SERVICE BULLETIN #122

04/14/14

8522 Spoke Wheel

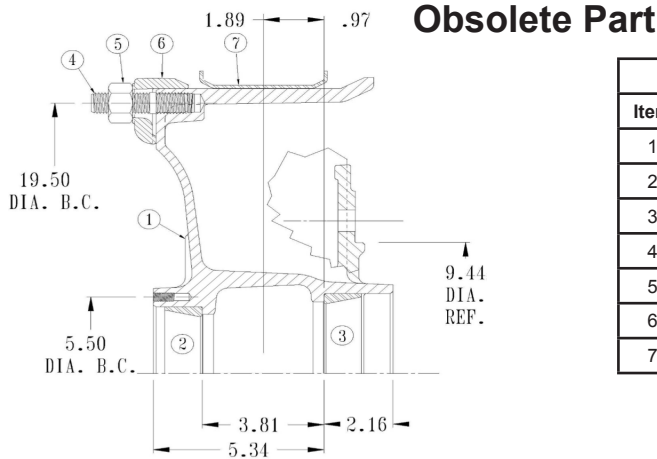
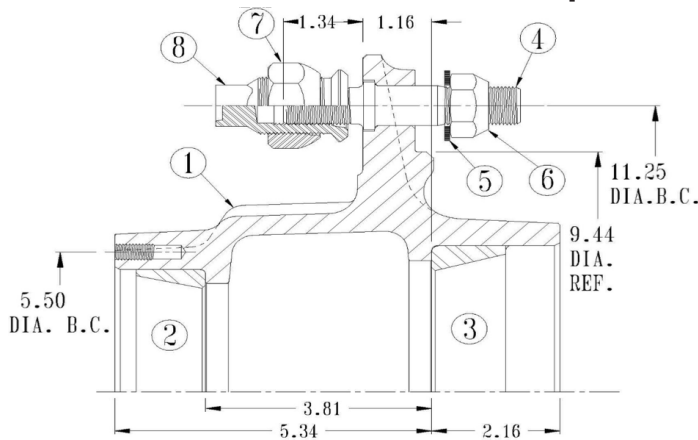
Upon depletion of inventory, the 8522 spoke will become obsolete with no direct replacement. We do however recommend a replacement: the 10-stud 1221 hub. This requires changing brake drums, changing to a disc hub, and changing to disc wheels instead of demountable rims. If you have any questions, please contact the Webb Engineering department via email to engineering@webbwheel.com or call 256-736-6356.

Replacement Option
